Reference: BB Ranch – Updated Site Plan and Condominium Submission (from May 10)
436 Front Rd - St. Williams – Norfolk County
Our File Project #10-094

The primary use remains a horse ranch and crops. The Resort Oriented Condominium through vacation accommodations, provides the opportunity for the equestrian experience and the opportunity for team building and local events. The saloon/restaurant provides for local food and beverages to the condominium guests, tourists, and local residents. The on-farm diversified uses comply with the provisions of the zoning by-law. There are both private and common elements managed and maintained by the Condominium Corporation.

April 2, 2024 Consolidated Comments							
Consolidated Comments	Planning Department	1	2-Apr-24	Following the review of the Zoning By-Law Amendment/Official Plan Amendment, Site Plan application and condominium application materials the following clarity is sought on the proposed uses: What is the maximum anticipated capacity for horses? For example, which each dwelling unit be required to board horses?	Boarding guests horses is not proposed at this time. Maintaining the owners own horses and ranch are primary. Capacity is

Drawing Title
SITE PLAN

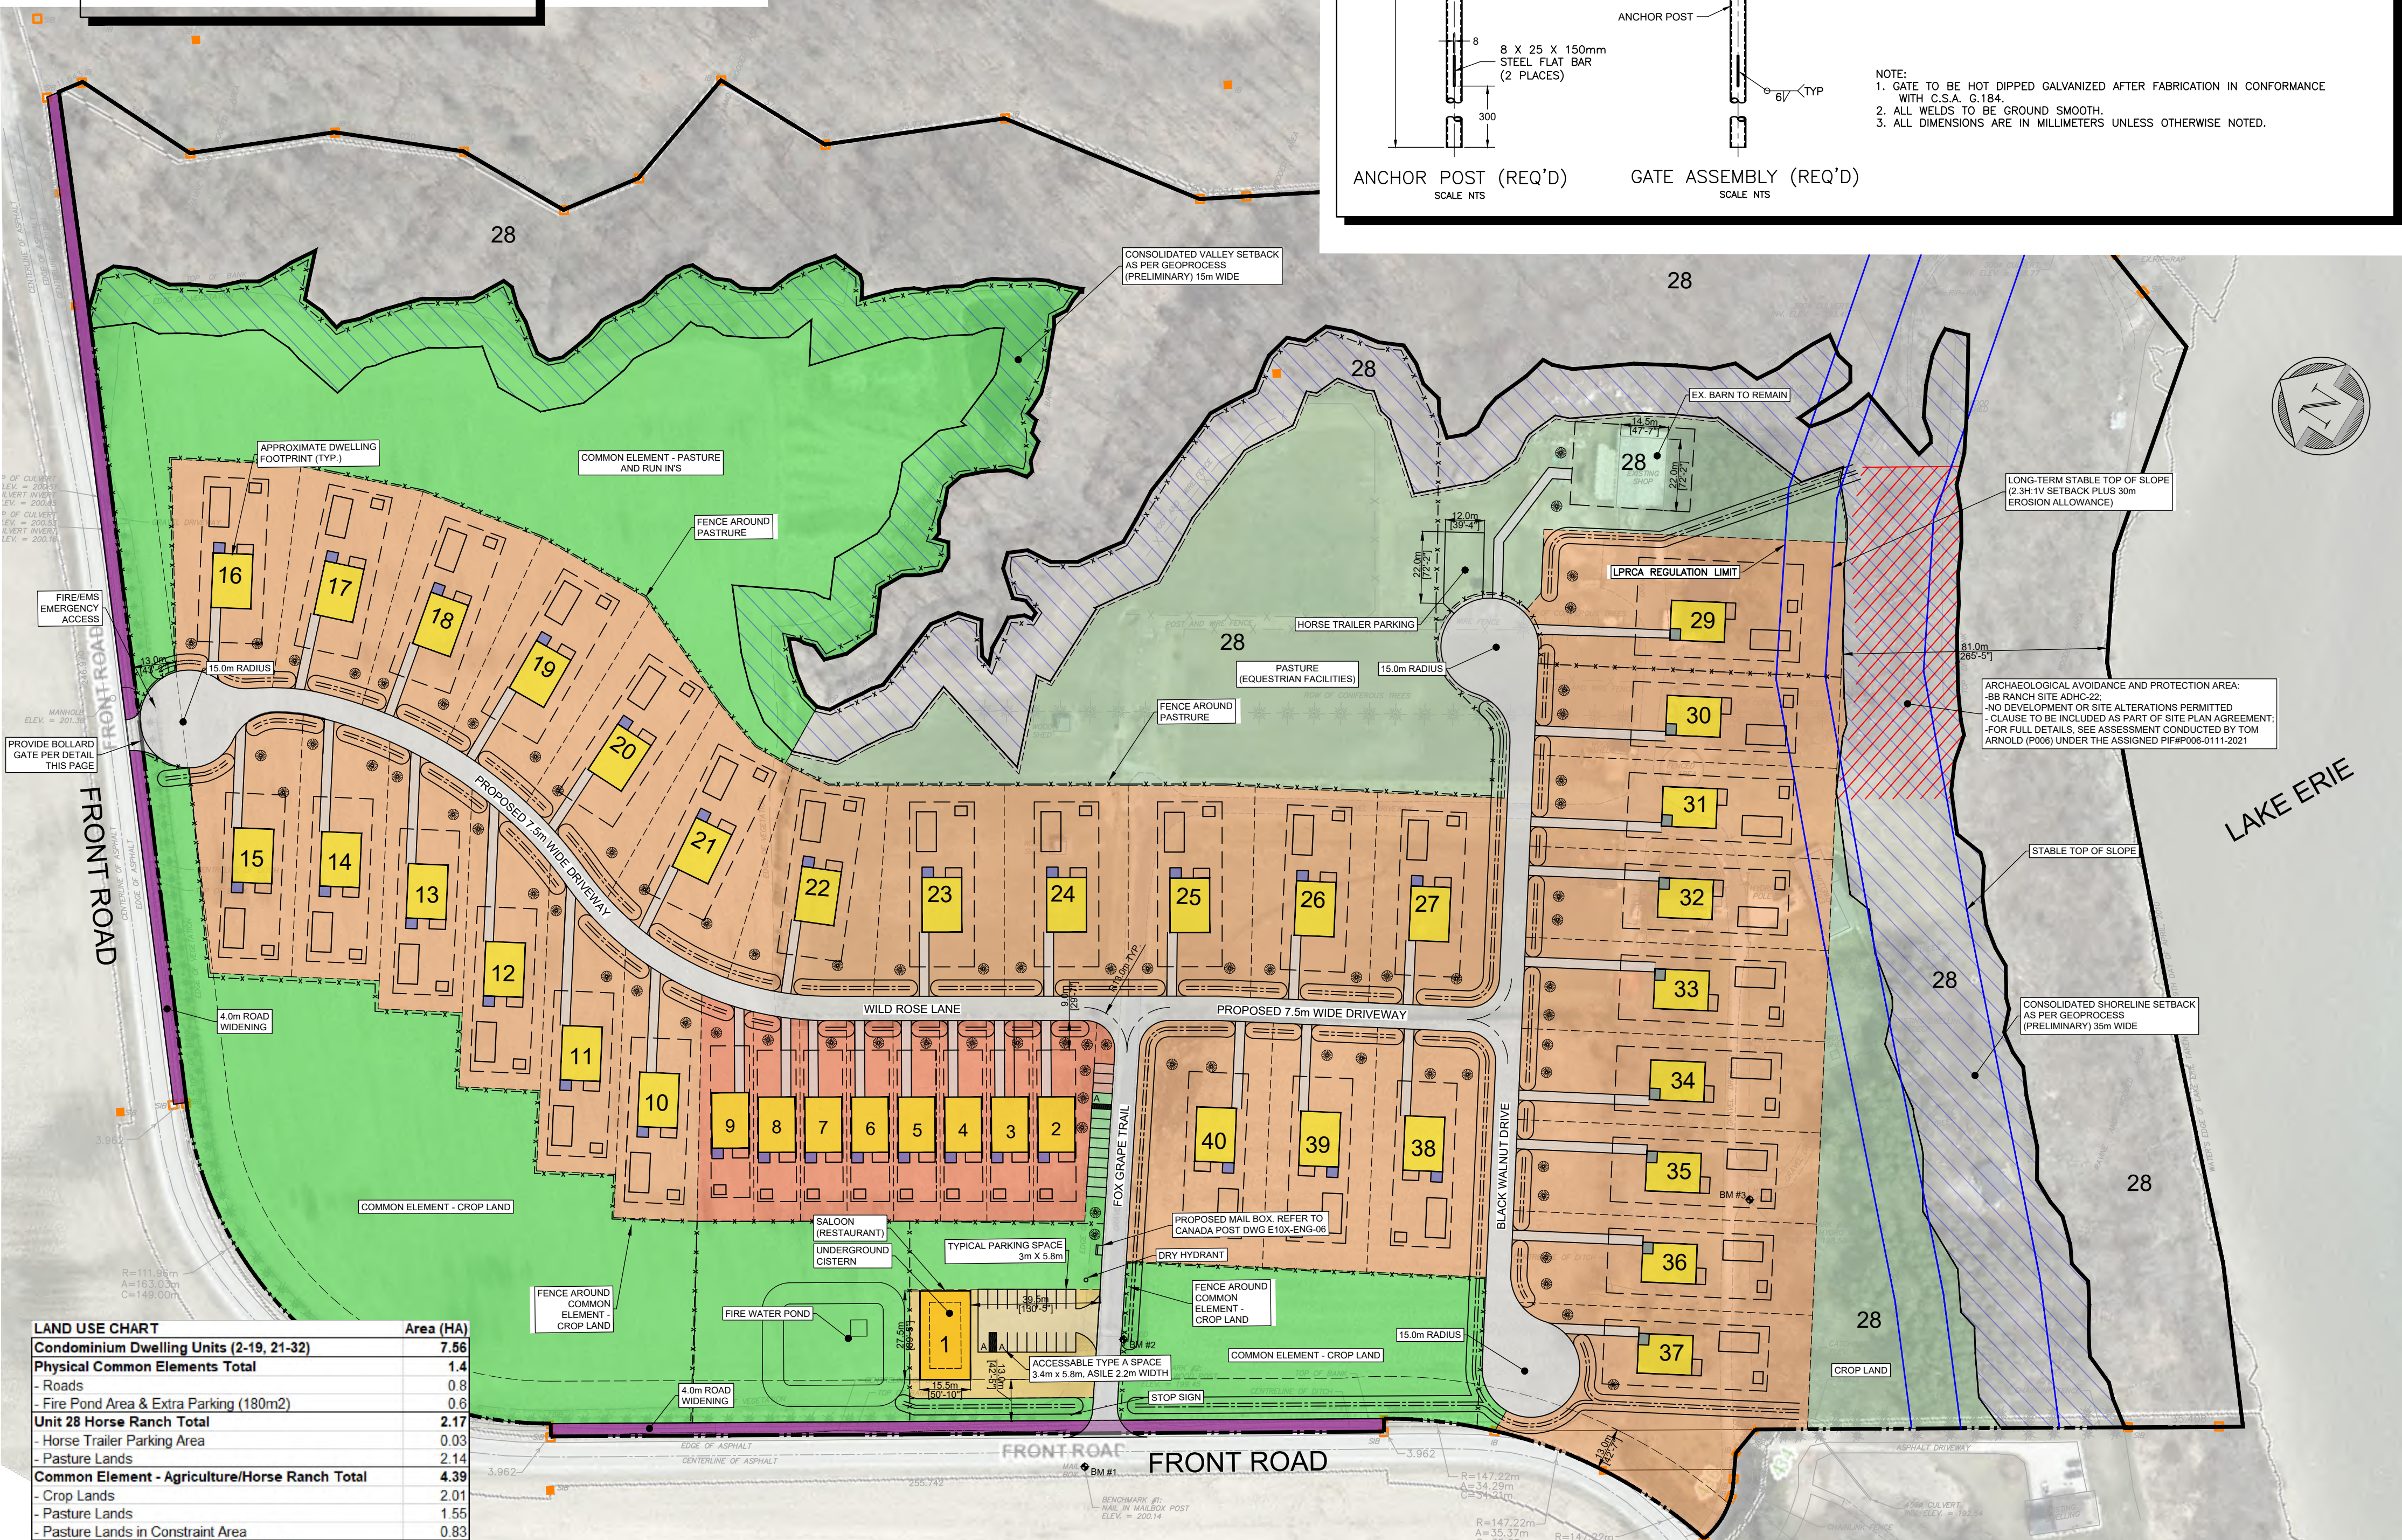
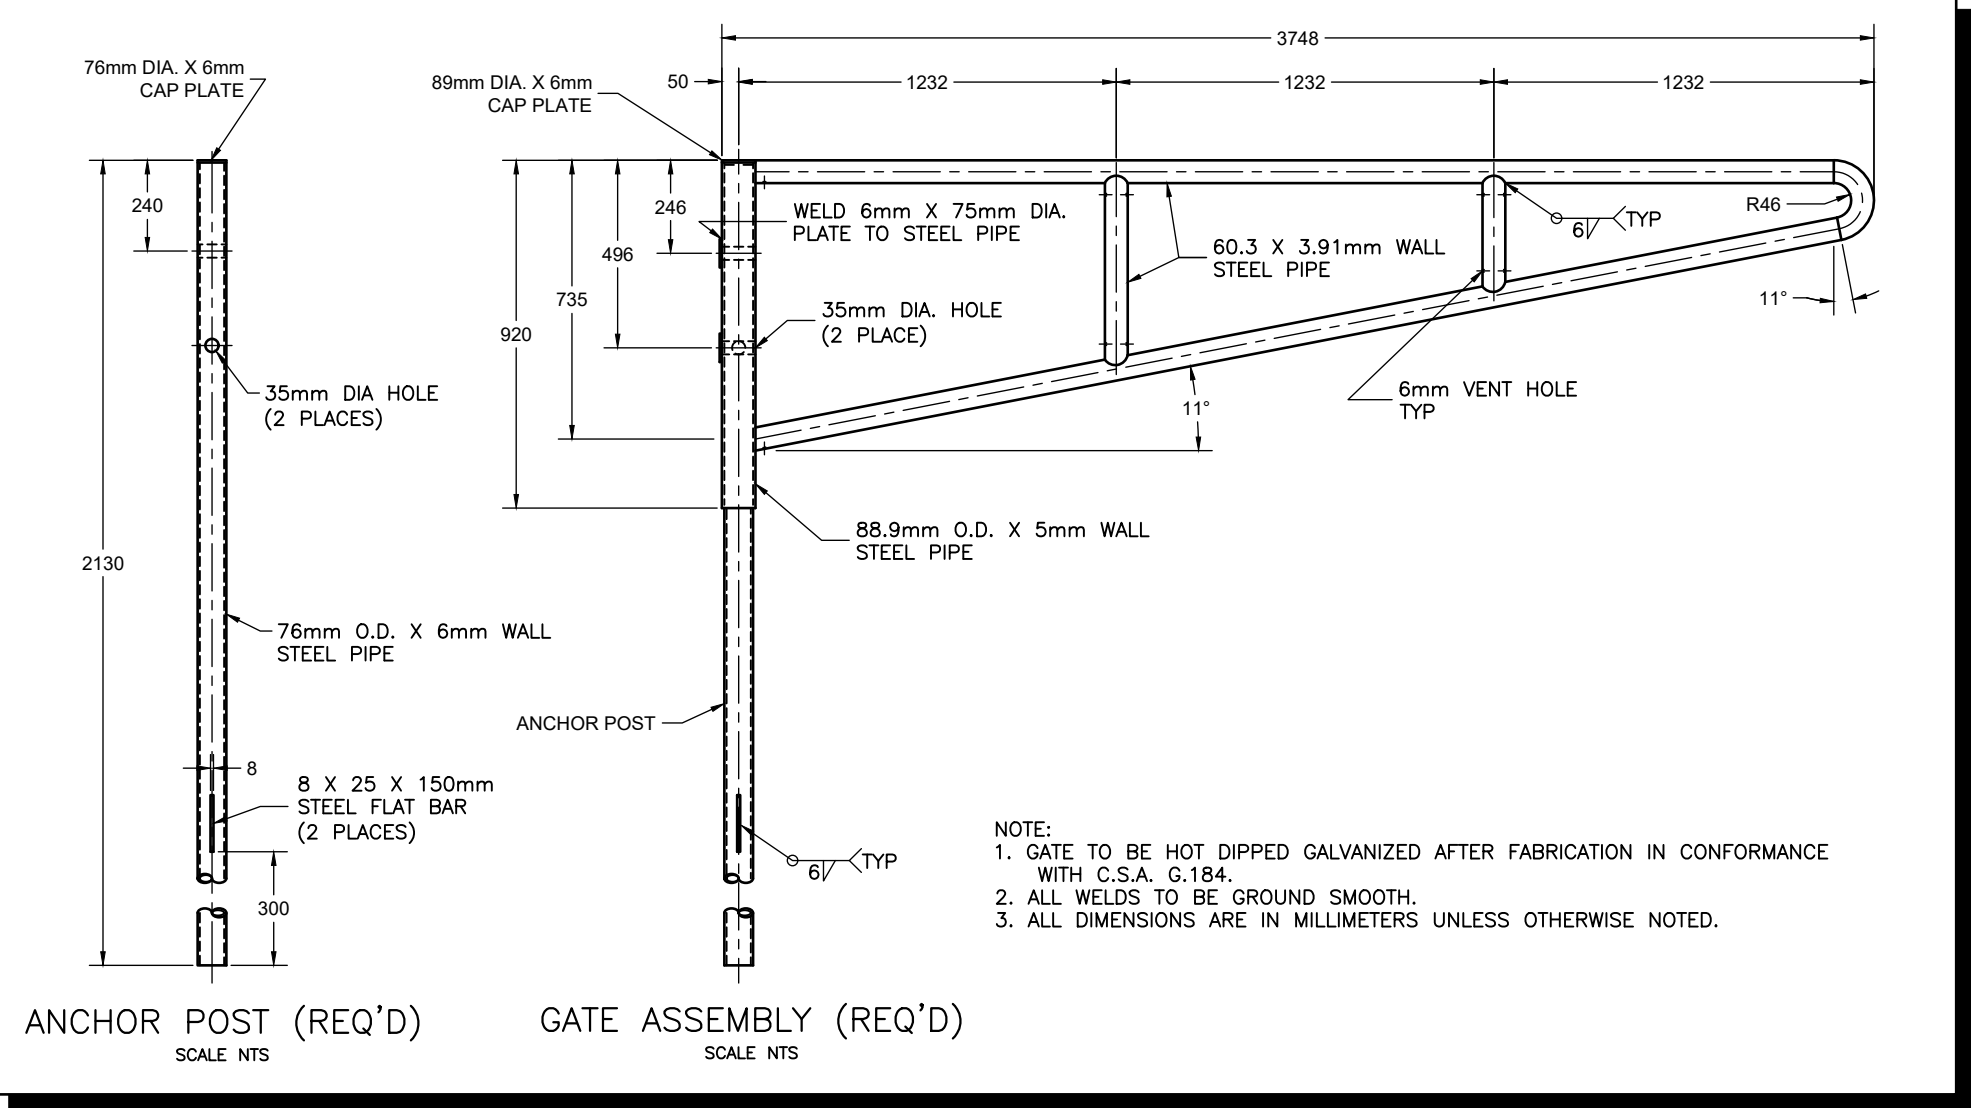
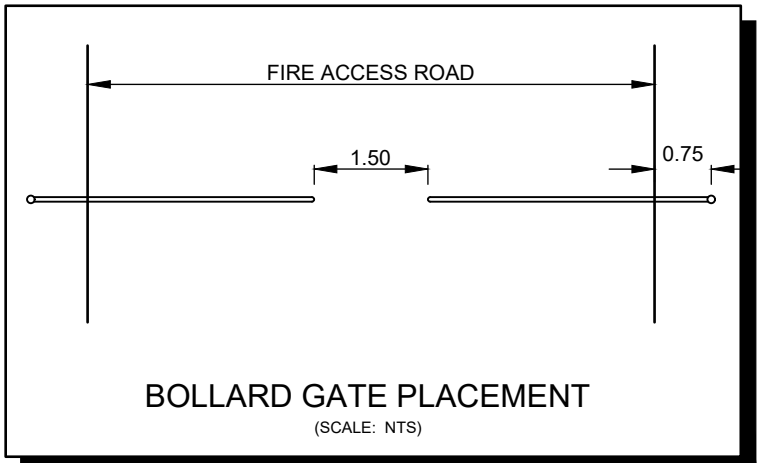
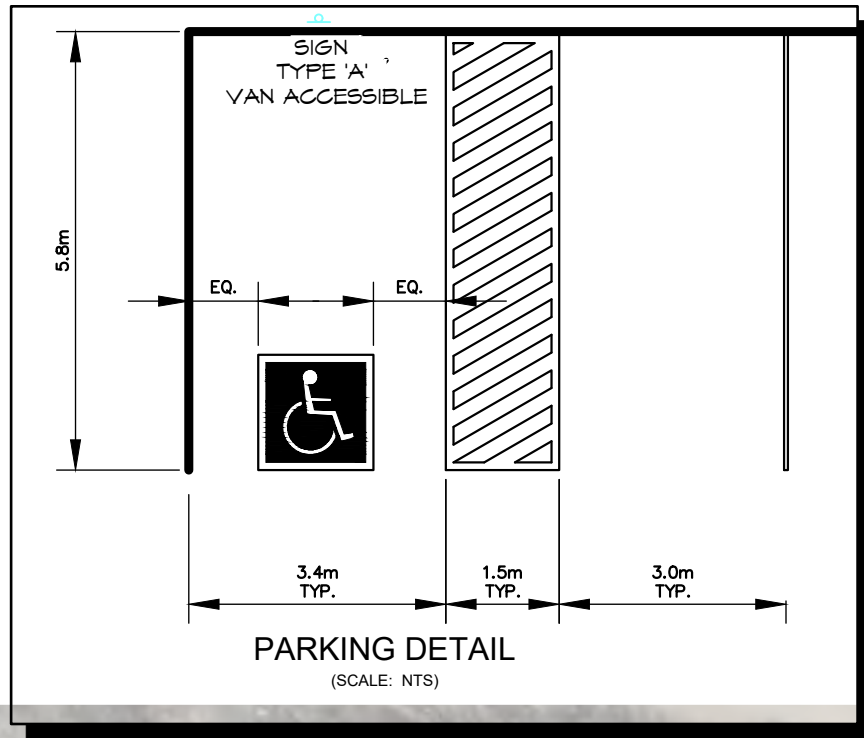
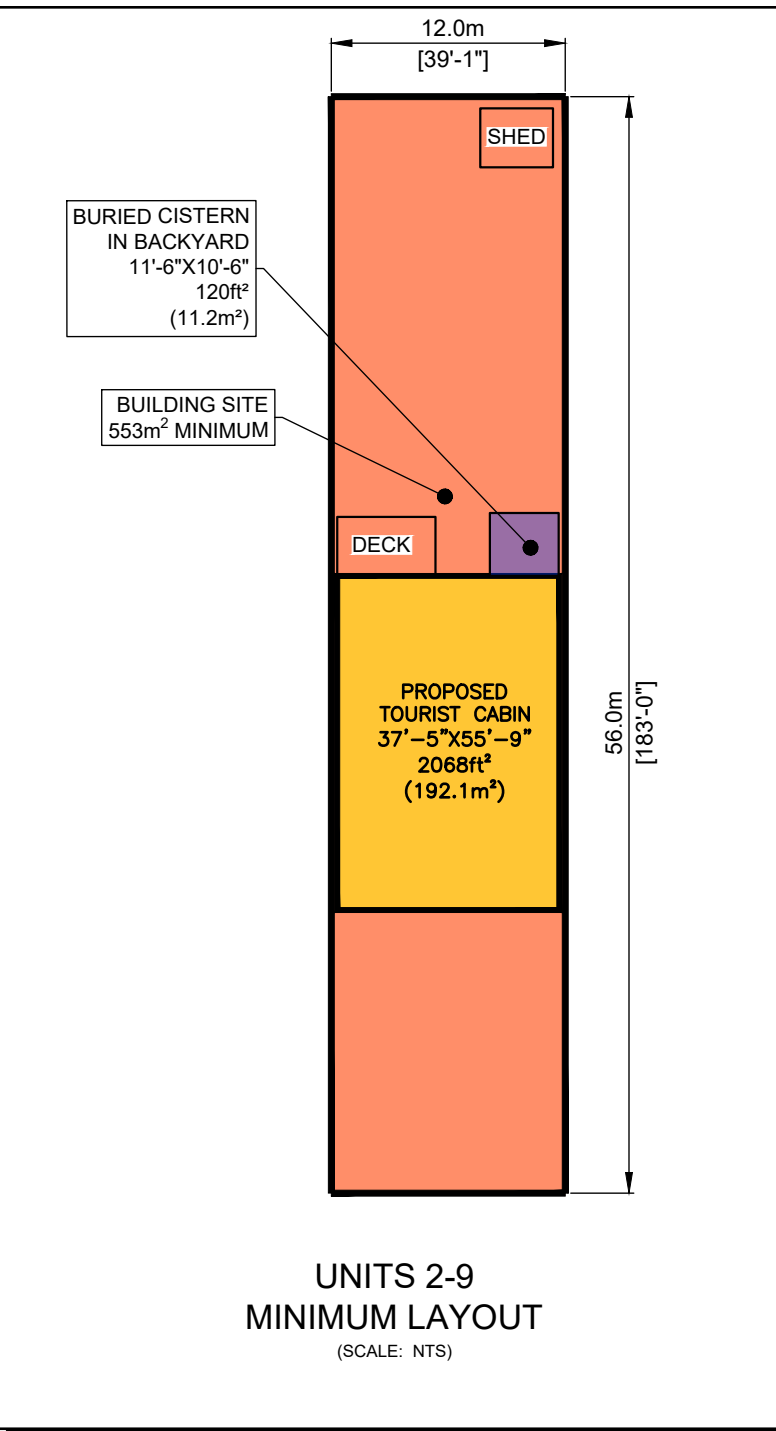
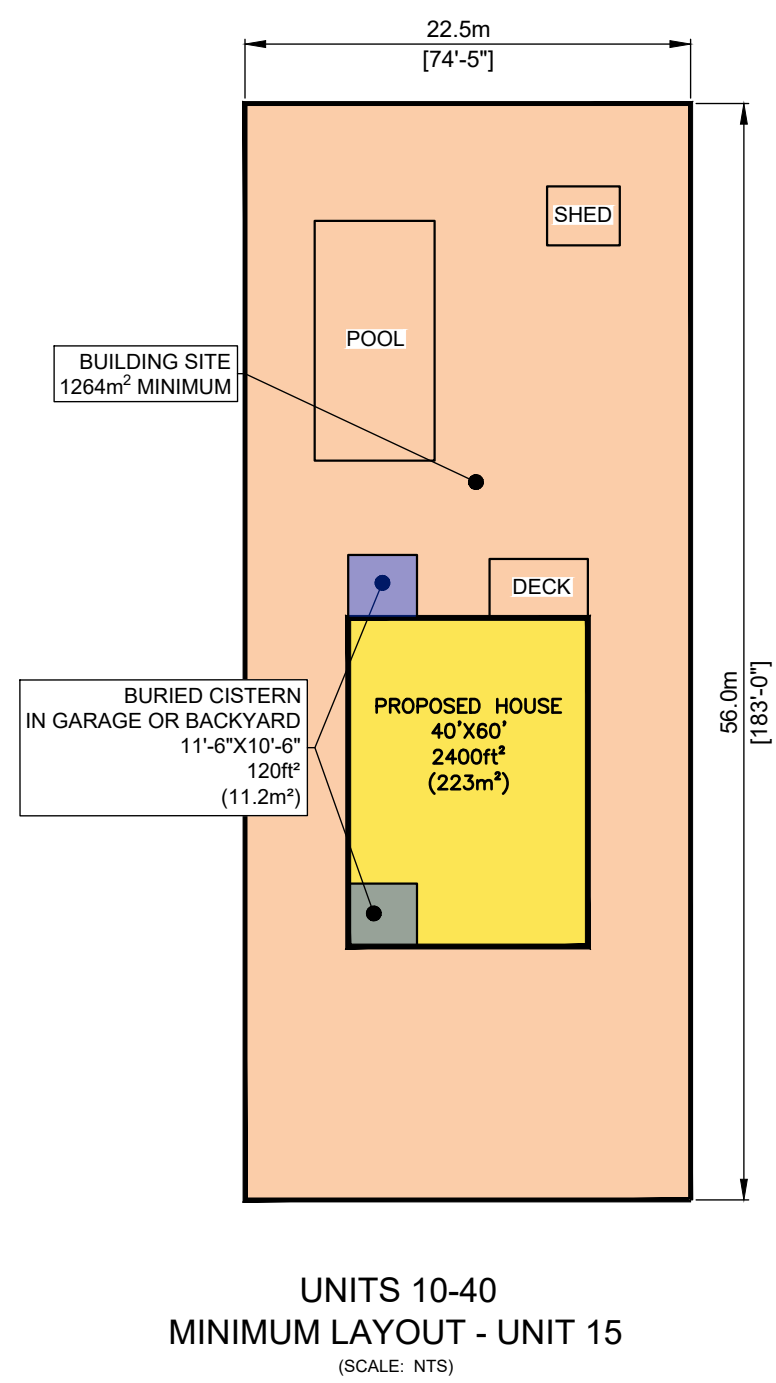
Consolidated Comments	Building Department	2	2-Apr-24	The septic systems shown on page Vallee Drawing C100 stamped 2023.12.08 are not adequately sized to provide the area needed to support a Class 4 septic system. As a Hydrological Study has not been provided to date, a percolation time (‘T’ time) of greater than 50 would be appropriate in the absence of detailed information and local historical data.	As of April 30th meeting with staff, see PML letter for location of septic systems. A D5-4 study is forthcoming.	PML/Vallee	Complete
Consolidated Comments	Building Department	3	2-Apr-24	Based on the sizes for dwelling provided in the updated Functional Servicing report dated the mantel area should be between 400 m.sq to 900m.sq. This is considerable more than the 136 m.sq indicated on drawing C100. Without knowing the number of bedrooms, finished floor area, or number of fixture units an accurate size cannot be determined. The mantel area is also to extend a minimum of 15m from the distribution lines. The proposed mantel areas minimum dimension are under 15m.	See PML letter.	PML	Complete

Consolidated Comments	Zoning Department	4	2-Apr-24	A zoning table needs to be provided on the site plan to detail parking for each use of the OFD uses, also parking for each farm dwelling unit, along with visitor parking as this is a condo development. A parking lot(or lots) for each use will need to be identified on the site plan and dimensioned.	See Update to site plan. Parking detail shows dimensions of accessible and standard parking spaces. Parking calculations shown. Please see driveway notes. The exact location of a driveway will be determined based on dwelling unit design, and location of septic system. 10 common element visitor spaces are required for the multiple farm dwelling units. 3 spaces are required for the OFDU (Cabins) and included on the plan. These 3 spaces are included in the 10,000m2 maximum space calculations. Parking lot has been dimensioned.	Vallee	Complete
Consolidated Comments	Zoning Department	5	2-Apr-24	The zoning table must also identify the front lot line, exterior lot lines, and rear lot lines and the distances that closest structures are to the property lines. Please identify current and proposed buildings.	See Update to site plan. See notes in addition to setbacks. The aerial photography shows existing buildings. However, since the buildings are going to be removed (except for existing barn), we do not detail the existing buildings.	Vallee	Complete
